IMPORTANT MEDICAL DEVICE SAFETY ALERT**Medtronic HeartWare™ HVAD™ System**

Product	Models
HVAD™ Pump Outflow Graft	1125
HVAD™ Pump Implant Kit	1103
HVAD™ Implant Accessories Kit	1153

April 2020

Appendix A: Outflow Graft Attachment excerpts from IFU (standard text) and Additional Steps (italicized underlined text)

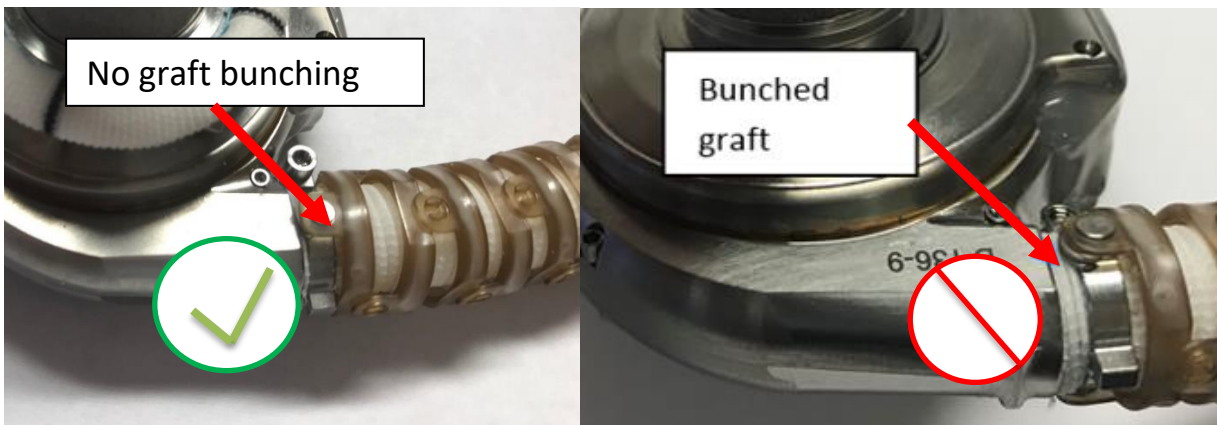
Avoid "bunching" of graft corrugations between the strain relief clamp and the pump body. While maintaining the fully loosened strain relief clamp over the pump outflow conduit, gently pull on the outflow graft to reduce corrugation bunching between clamp and pump body. Extra corrugations from the graft may prevent the strain relief clamp from being flush against the pump body, leading to the strain relief clamp being positioned over the pump outflow conduit ridge, potentially resulting in graft laceration while tightening.
